Correction to "Real-Time Vehicular Wireless System-Level Simulation"

ANJA DAKIĆ, MARKUS HOFER, BENJAMIN RAINER, STEFAN ZELENBABA, LAURA BERNADÓ, THOMAS ZEMEN (Senior Member, IEEE)

AIT Austrian Institute of Technology GmbH, 1210 Vienna, Austria

FIGURE 9: Measurement results of FER vs. SNR using an exponential PDF with K -factors $K \in \{-\infty, 10, 15, 20\}$ dB, RMS delay spread of 82 ns and Doppler bandwidth $f_{Dmax} = 100$ Hz, having $f_{Los} = 0$ Hz.

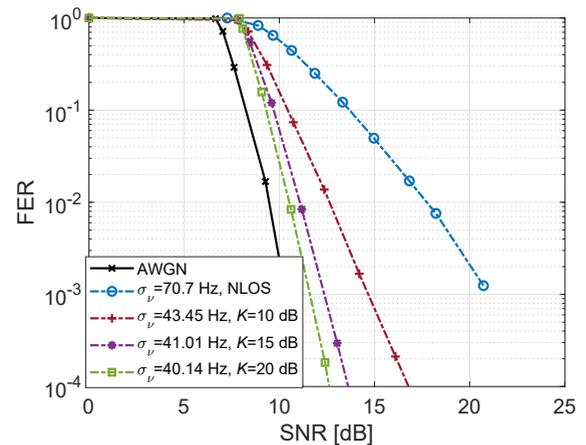
- Figure 9, Fig. 10 and Fig. 11 should be replaced by Fig. 9 - 11 from this correction.
- The complete text in Sec. V-A, subsection 3, discussing the results of Fig. 11, should be replaced with: "In Figure 11 we show the FER performance for different Doppler bandwidth values. In the NLOS case the best FER performance is obtained for the Doppler bandwidth of 100 Hz, which is the lowest one. Increasing the Doppler bandwidth

FIGURE 12: The FER vs. SNR measurement results for a Doppler bandwidth of 1000 Hz and RMS delay spread of 50 ns with $f_{LOS} = [0, f_{Dmax}, f_{Dmax}]$. All results are compared with the FER for a pure Rayleigh fading (NLOS).

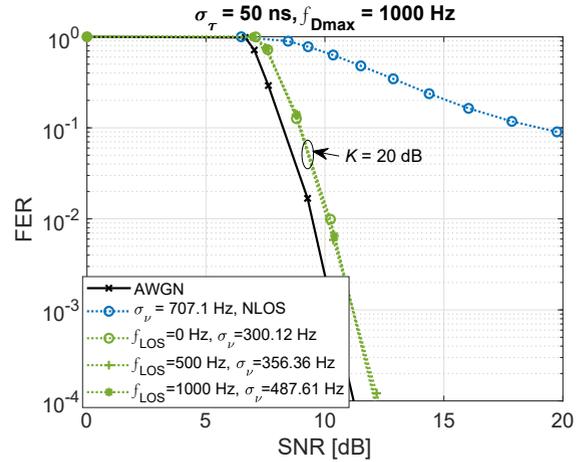
- The last five sentences in Sec. V-A, subsection 4, discussing the results of Fig. 12, should be replaced with:

- Figure 12 should be replaced by Fig. 12 from this correction.

"The results show that the Doppler shift of the

LOS component has no impact on the FER. Hence, in all strong LOS scenarios the carrier frequency offset compensation of the modem works reliably and provides close to AWGN performance."

FIGURE 16: FERs obtained by using the FER lookup table using our GSCM compared to the FERs obtained by emulating a measurement conducted for an inner city intersection scenario.

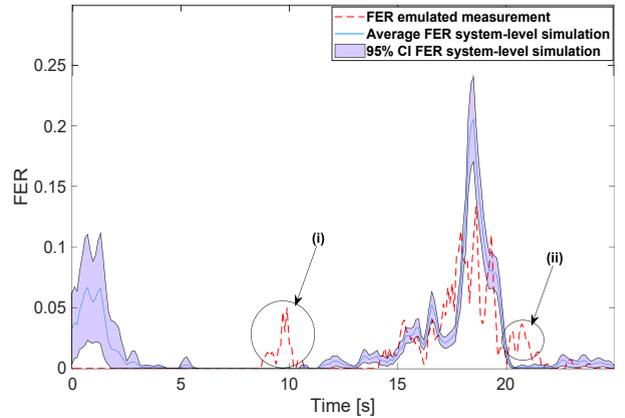
- Figure 16 should be replaced by Fig. 16 from this correction.
- The second last paragraph in the left column should be replaced with:

"Fig. 16 shows the average FER obtained by system-level simulation (solid line), the corresponding 95 % confidence interval (CI) (shaded area, contoured by a black solid line) and the FER we obtained by emulating the measurement data (dashed line)."
